CITY OF LA VISTA
MAYOR AND CITY COUNCIL REPORT
SEPTEMBER 15, 2020 AGENDA

Subject:	Type:	Submitted By:
PUD SITE PLAN AMENDMENT LOTS 1-4 ECHO HILLS REPLAT FOUR WEST MANAGEMENT, LLC	◆ RESOLUTION ORDINANCE RECEIVE/FILE	CALE BRODERSEN ASSISTANT PLANNER

**CITY OF LA VISTA
PLANNING DIVISION
RECOMMENDATION REPORT**

CASE NUMBERS: PPUD20-0003;

PARKING EXHIBIT: TURNING DIAGRAM FOR COMPACT VEHICLES / SPACES

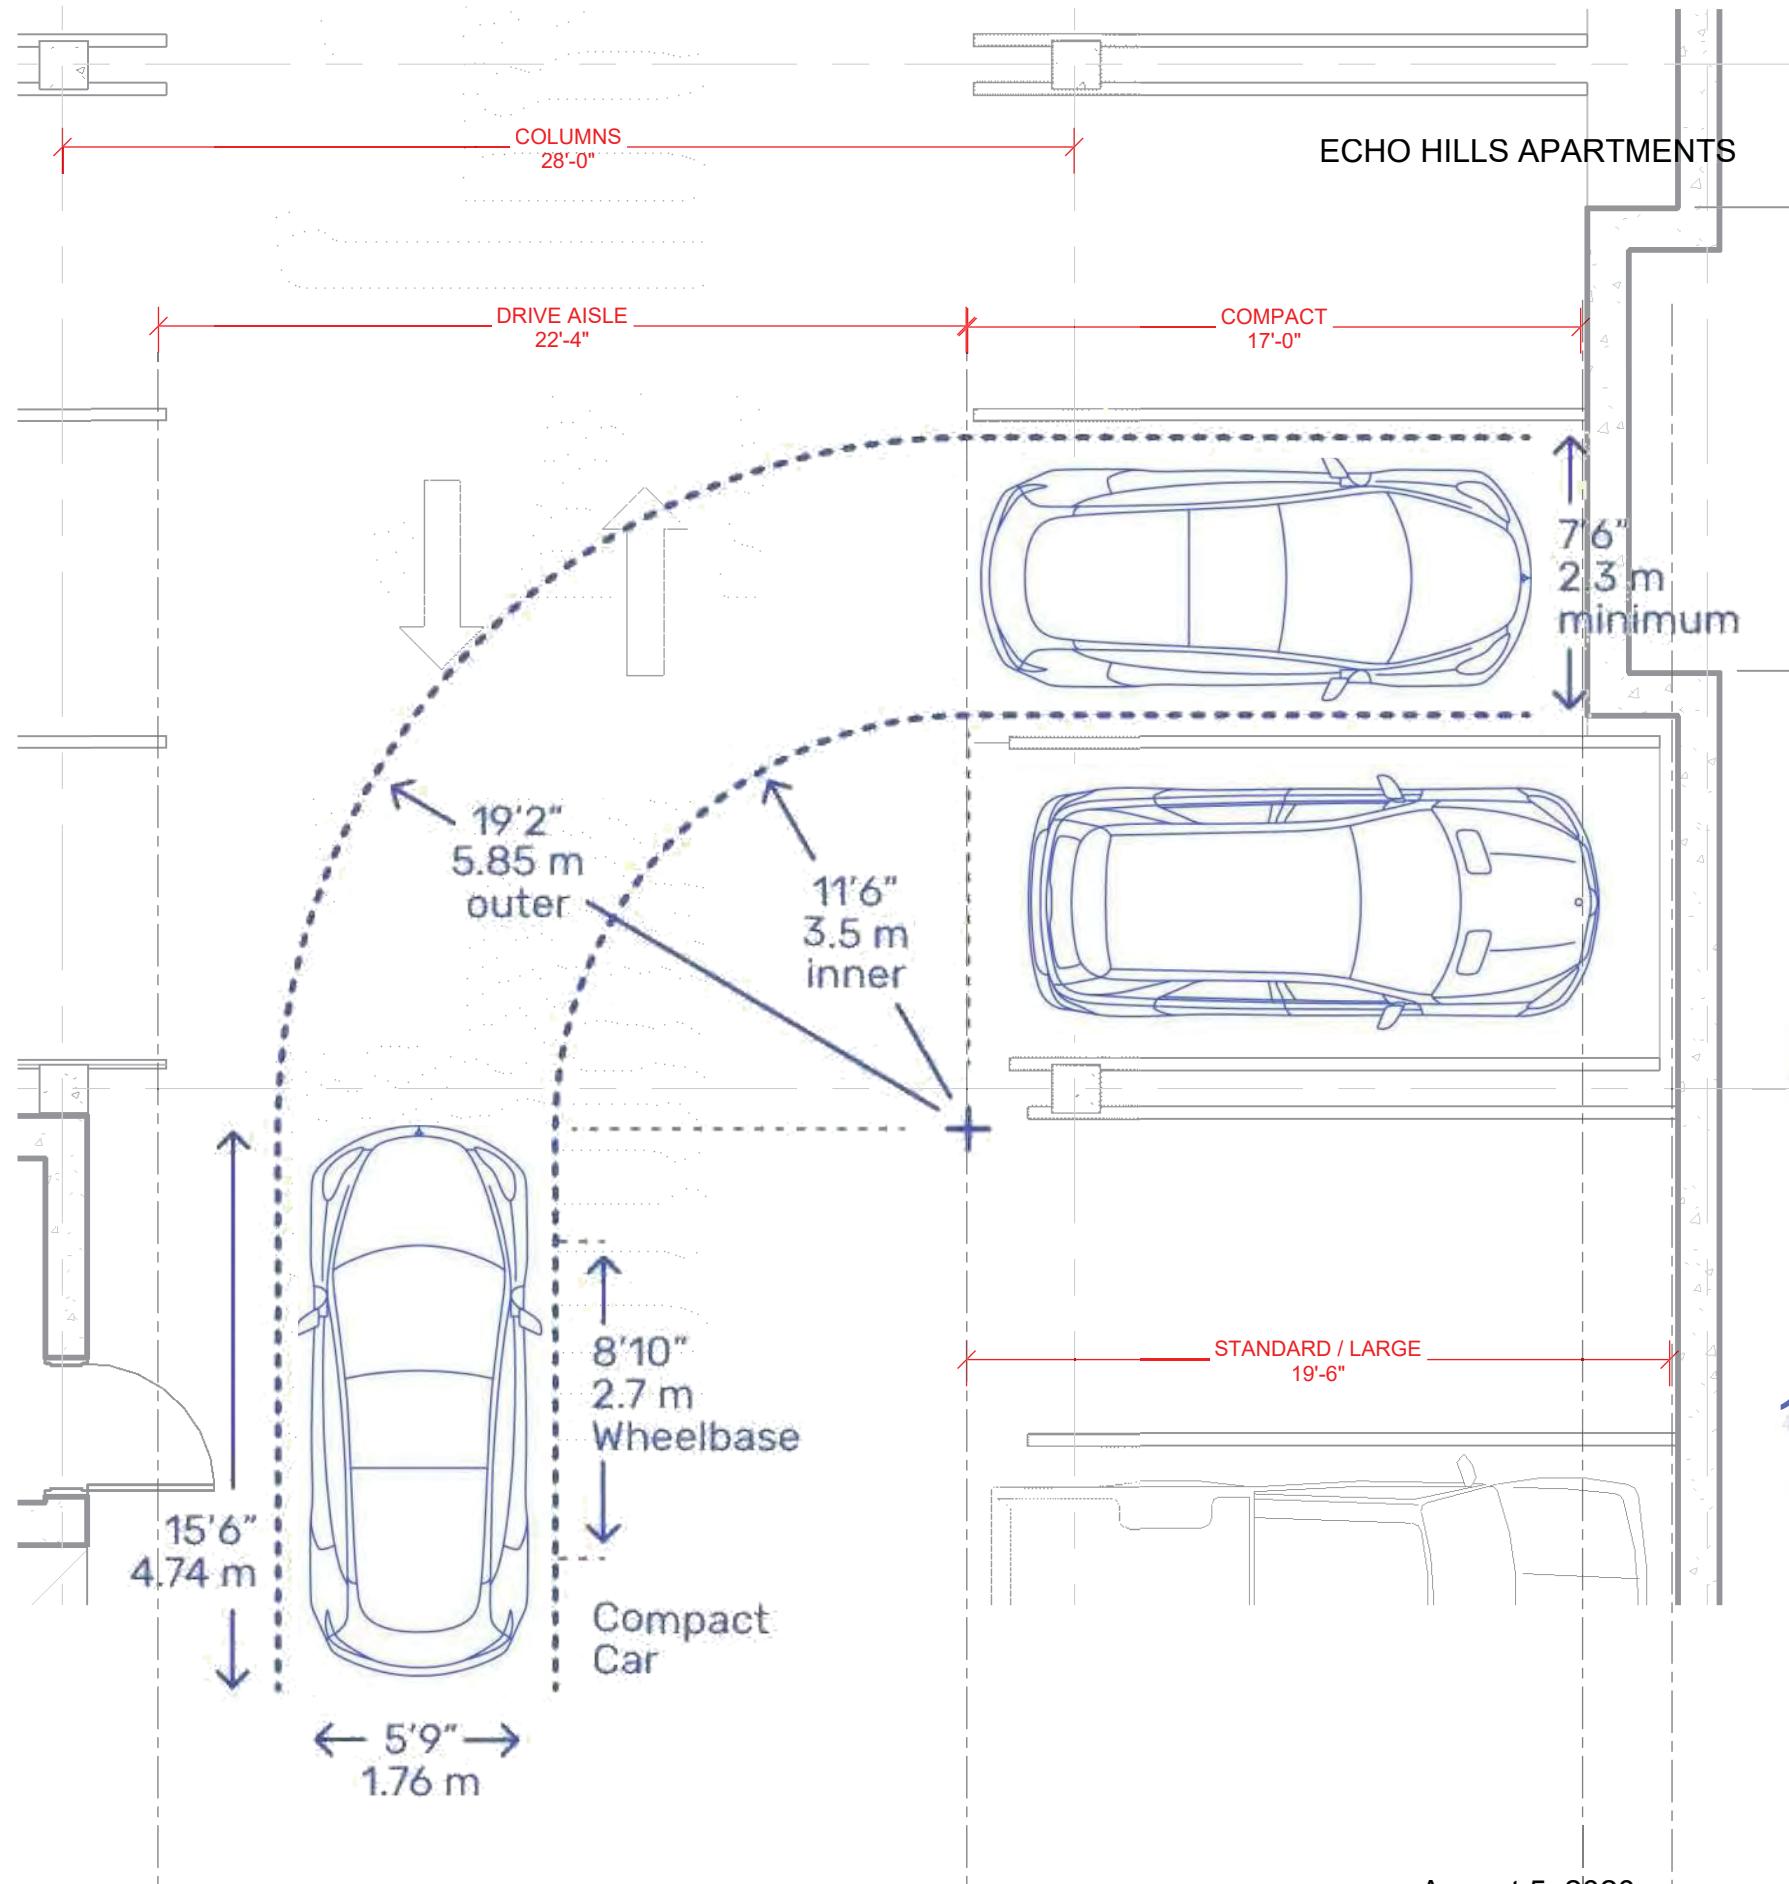
3. The proposed number of provided off-street parking stalls for Lot 2, Lot 3, and Lot 4 meet the required minimums per the La Vista Zoning Ordinance.
4. The applicant has requested approval of alternative parking stall dimensions for the 91 stalls in the underground parking garage under apartment building #3 on Lot 2. Standard configurations for 90-degree parking stalls, per Section 7.09 of the La Vista Zoning Ordinance are 9' wide by 18' deep with an isle width of 24' for two-way traffic. The proposed dimensions for the underground garage stalls include a 22'-4" drive isle width (a 1'6" reduction), and some stalls with a depth of 17' (a 1' reduction). Other stalls in the garage will have a depth of 19'-6" (an increase of 1'-6"). The Underground Parking Garage Exhibit, attached to this report, shows these stall dimensions and a sample turning diagram.

B. Omaha's standards include the following for 90 degree parking stalls: 16' parking space depth, 8' curb length (width), and 20' drive aisle width. The proposed compact parking stall dimensions for the spaces in the underground garage of apartment building #3 exceed all of the standard compact stall dimensions for the City of Omaha, as displayed in the table below:

Dimension	City of Omaha Compact Stall Dimensions	Proposed Dimensions for Apartment Bld. #3
Width	8'	9'
Depth	16'	17' minimum
Drive Aisle	20'	22'-4"

While some of the parking stalls in the underground garage will exceed the depth of a standard stall (19'-6" as compared to 18'), they still must be considered compact because vehicles accessing them must use a drive aisle width that is considered compact. The City of Omaha limits the percentage of compact parking stalls for any one facility to 40% of the total stalls, per Section 55-737 of their Zoning Ordinance. For Lot 2 Echo Hills Replat Four, which will contain the four apartment buildings, 29% of the total parking stalls would be considered compact if the alternative dimensions are approved and all 91 underground stalls are considered compact. The percentage of compact stalls for the entire development, which can utilize shared parking through the PUD, would be approximately 17%.

D. The City Engineer recommends approval of the proposed alternative compact stall dimensions, considering that all 91 stalls in the underground garage for apartment building #3 are classified as compact, as denoted on the PUD Site Plan attached to this report.
